Operator: HIGHPOINT OPERATING CORPORATION

Location Name: CB Rudd 6-61-18_19 SW7

Inspection: 696305339

Exhibit A

Exhibit C

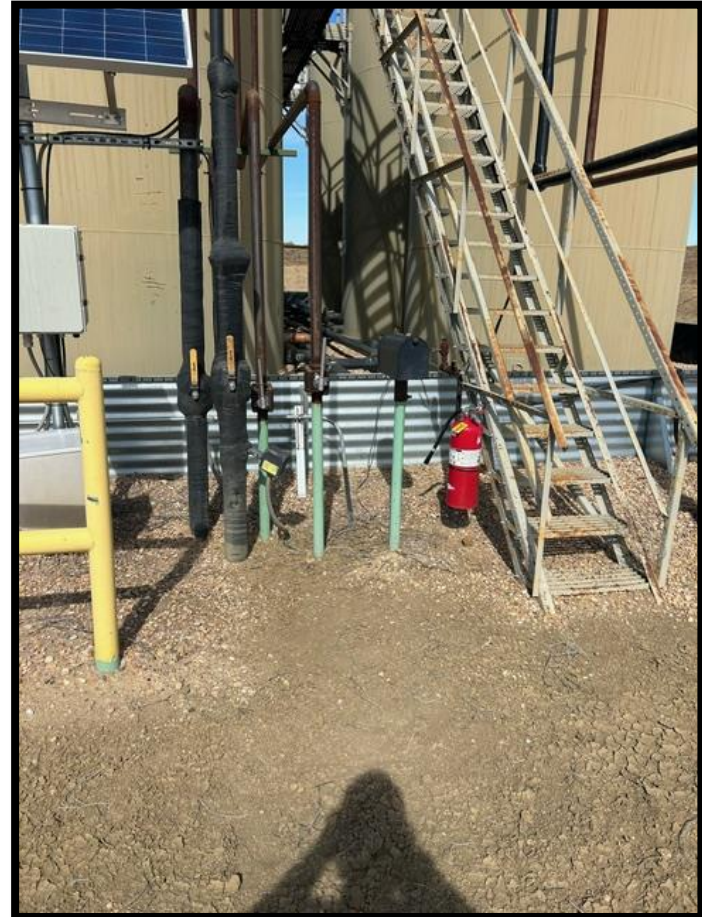
CA: Condensate Vault at VRU missing Capacity Label; see photos. Install sign to comply with Rule 605.h.

CA Resolution: Labels regarding Content, Capacity, and NFPA has been updated and installed to comply with Rule 605.h.
